**SERVICE**  
**570 TELEPHONE SETS**  
**(EMERGENCY REPORTING)**

**1.001** This addendum supplements Section 502-580-455, Issue 3.

**1.002** This addendum is issued to:

Fig. 6—8J and 8K Apparatus Units, Current Connections (MFD after Sept. 30, 1971)

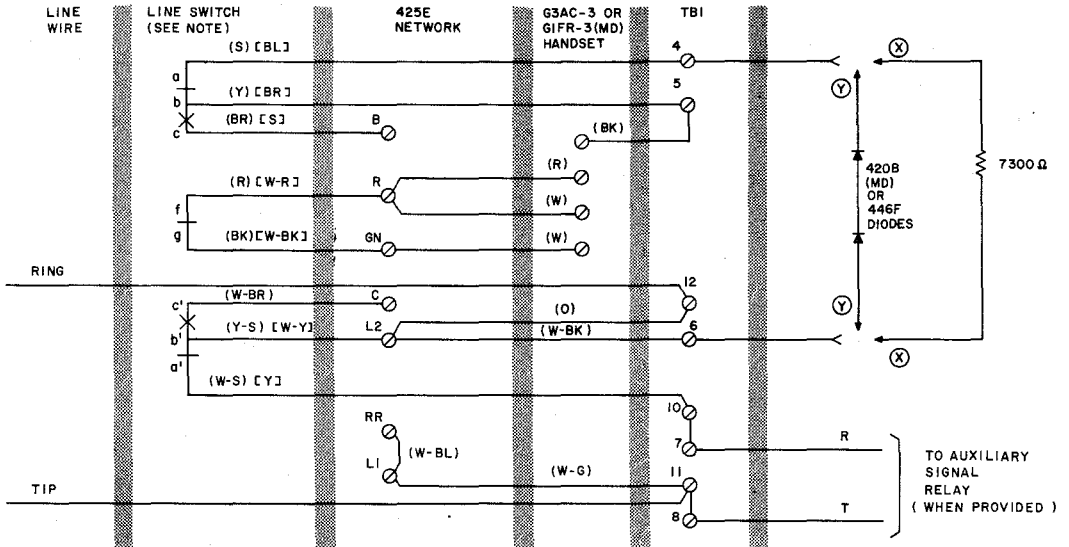
- Add connections for 8J and 8K apparatus units manufactured after September 30, 1971 (Fig. 6)
